# FIELD INSPECTION REPORT

Project Name:	Mountain Valley Pipeline	Inspector:	Matthew Grant
Inspection Date:	Wednesday, September 29, 2021	Project Contact:	Brian Clauto
Spread H: Montgomery	AR 270, 270.01 ATWS 1163, 1162 St12072-12106+77	Weather:	Dry

# FIELD INSPECTION PHOTO LOG

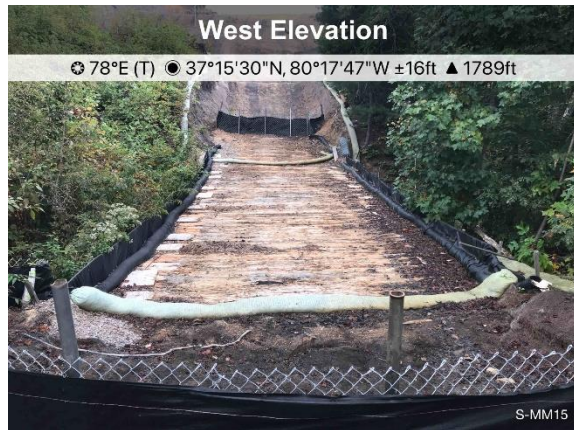
- Figure 1: Matting has deteriorated on slopes leading to S-MM15.

- Figure 2: Designated crossing S-MM15, ECD's are in place for active construction. Matting on both sides of crossing has deteriorated.

- Figure 3: Designated crossing S-, ECD's are in place for active construction.

- Figure 4: Matted slope on coming in side leading to designated crossing S-MM14 has deteriorated.

**Recommended Corrective Action:** Maintain and install all controls per the approved PSS&S.
